CUP-95-121

Project Name: BFI Recycling Center

TITLE HEADING: Site Plan Review - BFI Recycle Center

Re: Response to Review Comments, BFI Recycle Center, File # CUP-95-121(2), Job #95181.40.

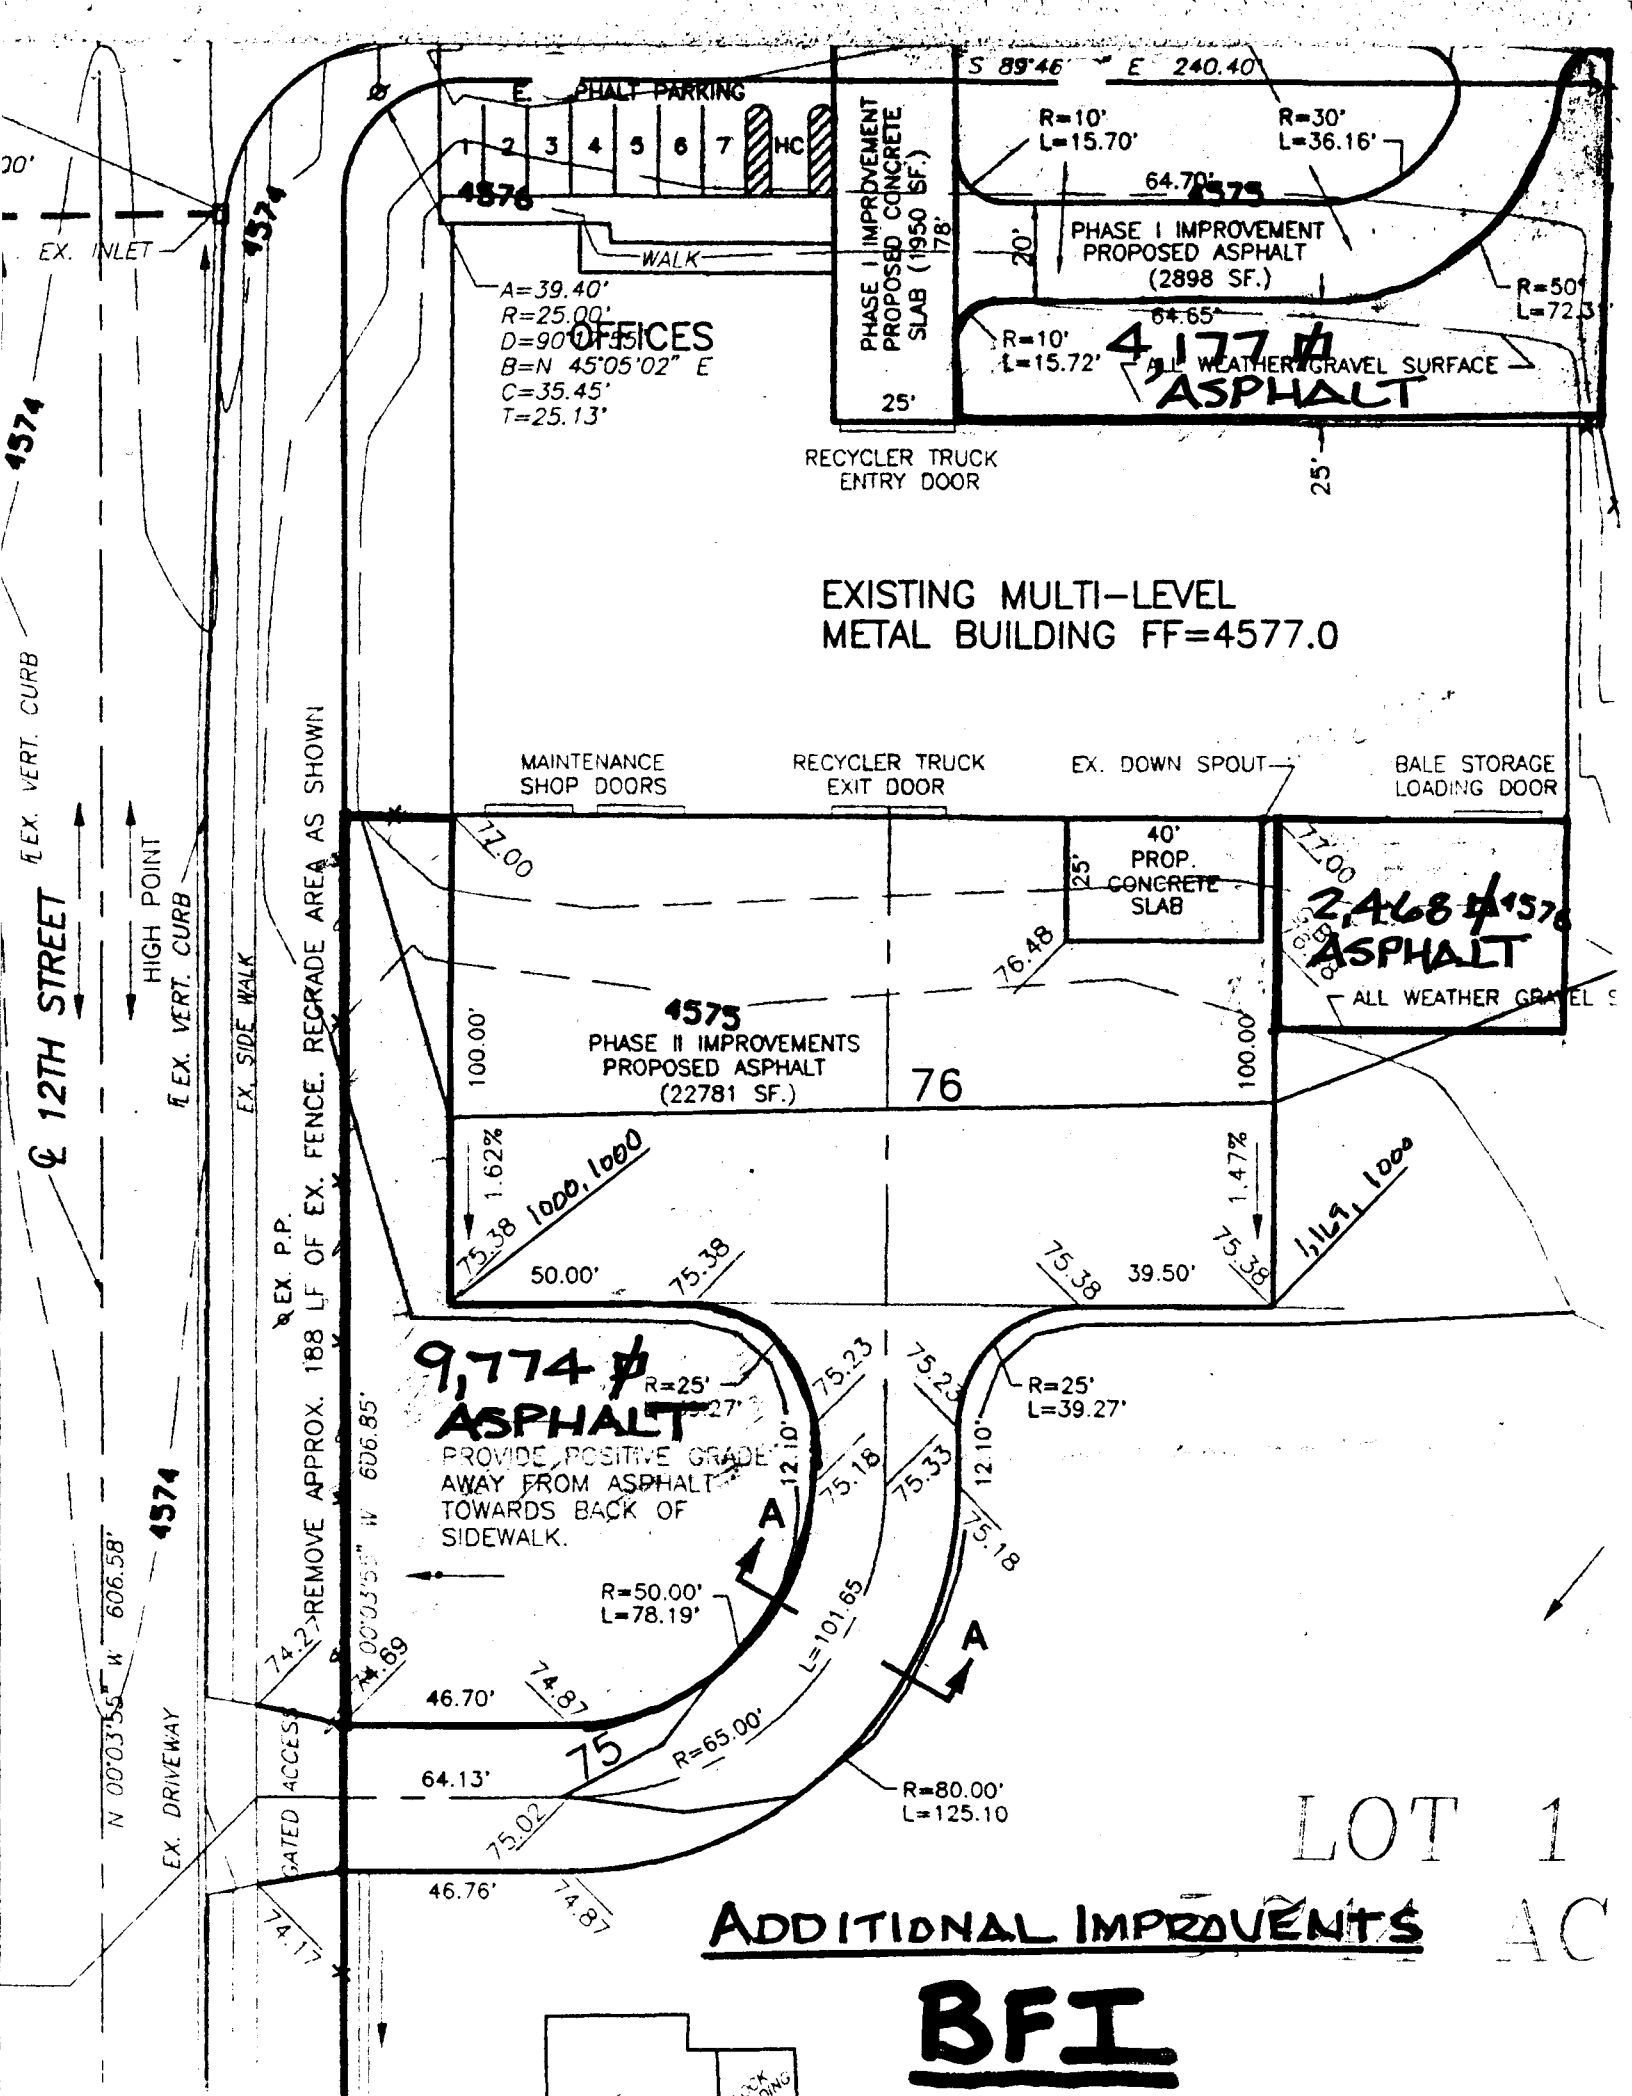
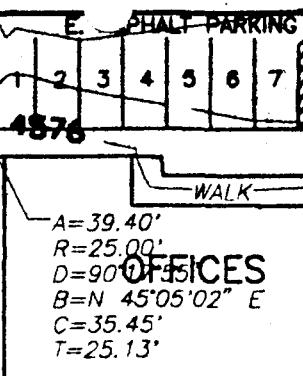
1. Approval of the Conditional Use Permit required that the south property line be screened with screen fencing and/or landscaping. The site plan must show those improvements.

2. Approval of the Conditional Use Permit also required that the street frontages and rights-of-way must be landscaped. The plan must show the proposed ground cover for the landscaped area behind the sidewalk along 12th Street. The area between the sidewalk and curb must also be landscaped. Please indicate what is proposed.

3. All landscaped areas must be served by a pressurized underground irrigation system. The plan must reflect that.
4. A staging area should be provided in the space in front of the building just east of the parking spaces for vehicles to pull in and wait for access to the entry door to drop off recyclables. The proposed concrete slab will not provide sufficient space for individual recyclers to wait to drop off their materials (see attached drawing for suggested configuration).
5. To determine the Transportation Capacity Payment please supply information on the prior use of the property and the number of trips generated from the site and additional information on BFI's estimated trip generation.

1. Drainage fee calculations are acceptable.
2. Please revise circulation area in front of building on Winters in accordance with Community Development comments.
3. Information on previous use of building and anticipated number of trips for proposed use is required to calculate Transportation Capacity Payment.

2. The Landscaping Plan has been revised to show that a "Rock Mulch" is to be installed along 12th Street as a ground cover between the back of curb and the detached sidewalk and behind the back of sidewalk to the R.O.W. line.

The total number of street trees has been increase to meet with the requirement of 1 tree per 40 lineal feet of street frontage. Minimum shrub coverage at maturity is defined on the plan.

Landscaping, including street trees has been added along Winters Avenue between the roadway and the new asphalt driveway in the front of the building.

3. The Landscaping Plan has been revised to show a proposed "Drip Irrigation System". All landscaped areas are to be irrigated by this system.

4. A 20-foot wide asphalt driveway has been added to the plans. This driveway shall provide "pull in and wait" access to the recycler entry door as recommended by the review comment.

2. The circulation pattern has been revised with the addition of the asphalt driveway in the front of the building.
